5. Quartz Creek Subdivision Wilkes Addition; KPB File 2024-053 Edge Survey & Design, LLC / Wilkes Location: Sterling Highway & Persistent Way Cooper Landing Area / Cooper Landing APC

### ITEM #5 - PRELIMINARY PLAT QUARTZ CREEK SUBDIVISION WILKES ADDITION

KPB File No.	2024-053
Plat Committee Meeting:	June 10, 2024
Applicant / Owner:	Onie Ray Wilkes / Cooper Landing, AK
Surveyor:	Jason Young / Edge Surveying and Design, LLC
General Location:	Sterling Highway, Persistent Way, Cooper Landing, Cooper Landing APC
Parent Parcel No.:	119-124-21
Legal Description:	Tract D-2 Quartz Creek Subdivision James Addition SW 2005-14
Assessing Use:	Residential
Zoning:	Rural Unrestricted
Water / Wastewater	Onsite
Exception Request	none

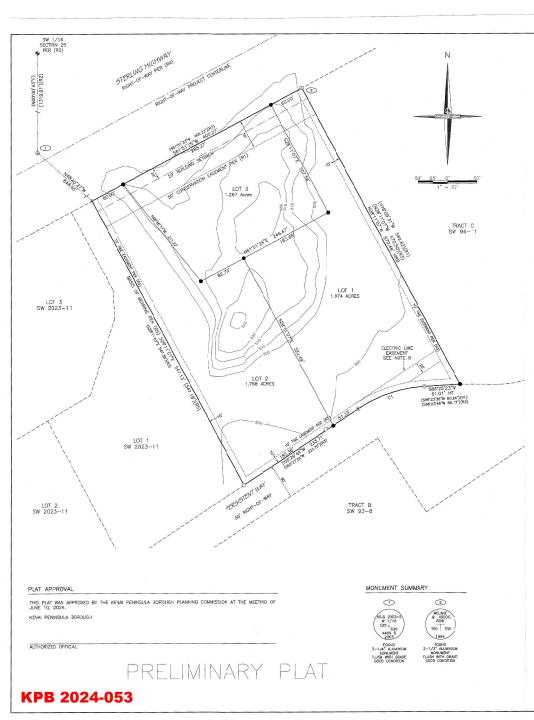
There are steep areas indicated by the contours shown on the drawing but they are not called out. **Staff recommends** prior to submittal of the final plat the contours be removed and the steep areas over 20% be noted on the drawing.

The property is subject to a 50 foot conservation easement abutting the Sterling Highway. The plat shows the required 20 foot setback which will be within the conservation easement. **Staff recommends** the setback remain in case the 50 foot conservation easement was ever terminated but at this time the terms of the conservation easement take precedent to the allowed uses of a setback as defined in KPB Code. The conservation easement along with a deed restriction were put into place by the Kenai Peninsula Borough prior to the parcel being sold. It appears some of the conservation easement may have been cleared. The status of the conservation easement will need to be verified and if any clearing or use is determined, staff will need to forward the information on to the KPB Code Compliance Officer to determine if the terms of the proposed plat are compliant. **Staff recommends** the surveyor verify if any portion of the 50 foot conservation easement has been cleared or has been used.

There appears to be a possible encroachment in the southwest corner of the property from the neighboring property. The surveyor was contacted about the issue and it was confirmed that there is no issue and the apparent items are wood piles and construction materials piles that will be moved.

<u>Utility Easements</u> The affected utility providers were emailed the subdivision plat public hearing notice as part of the routine notification process. In response to the mailings, Chugach Electric has requested a 20' T & E Easement along the front behind the 50' Conservation Easement. All other responses have been answers of no comment. Staff recommends to grant utility easements requested by the utility providers or work with the utility providers to obtain approval.

Change the KPB to 2024-053 Add OA to the front overall distance Steep slopes (20-80%) need shown on drawing. Plat Note #7, remove the second "-0" in the third line serial notation.

- Change the KPB to 2024-053
- The parent subdivision complete name is: Quartz Creek Subdivision <u>James Addition</u>, please correct accordingly.
- Add Alaska after the Seward Recording District in the legal description.
- 'Seward Recording District' is not needed in the lower legal description above the owner's portion and change "owners" to owner.
- C. The location, width, and name of existing or platted streets and public ways, railroad rights-of-way, and other important features such as section lines or political subdivisions or municipal corporation boundaries abutting the subdivision;

Add Right-of-way Varies to the large area of Persistent Way ROW.

Steep slopes (20-80%) need shown on drawing.

Possible encroachment in southwest corner of plat need verification from surveyor

B. The following note shall be shown on the final plat: No permanent structure shall be constructed or placed within a utility easement which would interfere with the ability of a utility to use the easement.
Staff recommendation: comply with 20.60.150.
Chugach Electric wants a 20' T & E easement added behind 50' Conservation easement.
